MEMORANDUM

RE: Heather's Place S/D

Discussion of David Fitzpatrick, P.E.'s request for a waiver to construct a boulevard entrance into Heather's Place.

HEATHER'S PLACE

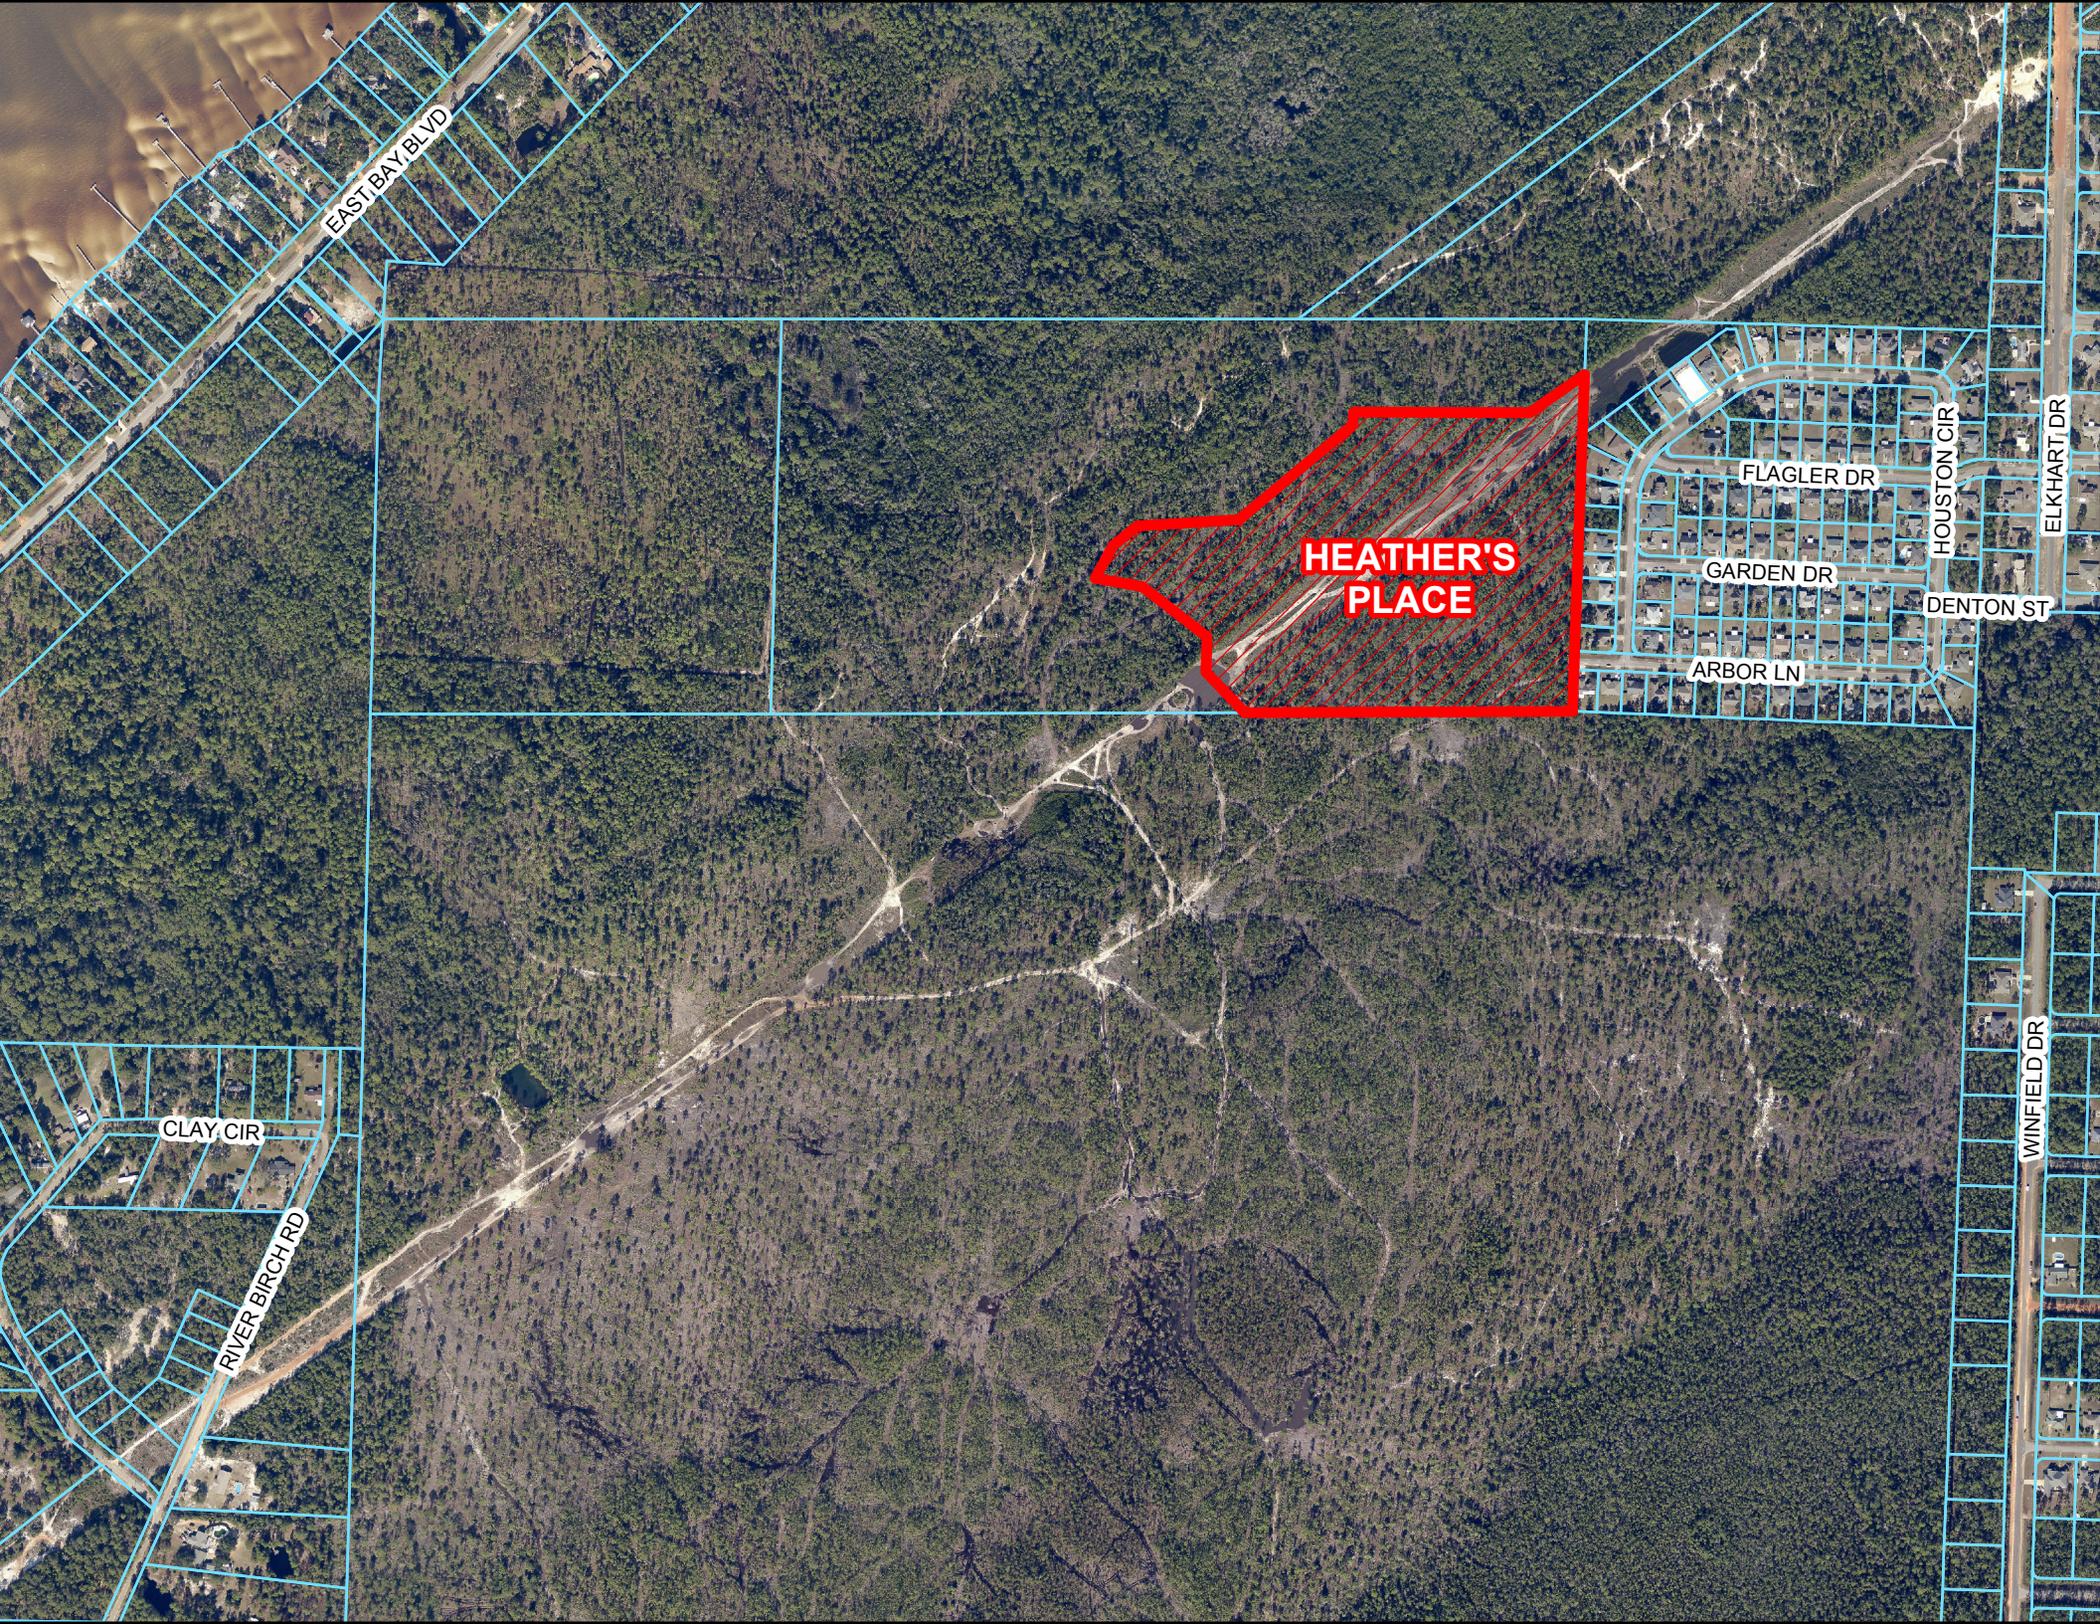
We respectfully request a variance to the boulevard entrance requirement of the land development code. The referenced proposed subdivision is comprised of 60 single family homes.

- The subdivision access point is Arbor Lane an existing 60' county right of way stubout to the subject development. Santa Rosa County Engineering staff has requested that the existing right of way not be converted into a boulevard type entrance and that we simply connect to the existing asphalt stubout there.
- The applicant is planning a 2nd phase to this development in the future which will connect to another county right of way. This connection would negate the need for a boulevard entrance at Arbor Lane.

LDC 4.03.03.B.3.b requires a subdivision of 50 lots or more have 2 entrances or a boulevard entrance to the first looped street. Entrance to the subdivision will be from a 110 foot stub-out of Arbor Lane that is constructed as a non-boulevard street. It is not recommended that this portion of Arbor Lane be removed and reconstructed as a boulevard. Also, a boulevard requires a 65 foot right-of-way and Arbor Lane has only a 60 foot right-of-way. Subsequent phases of this development will provide for a second entrance.

Board approve or deny a variance for the boulevard entrance into Heather's Place.
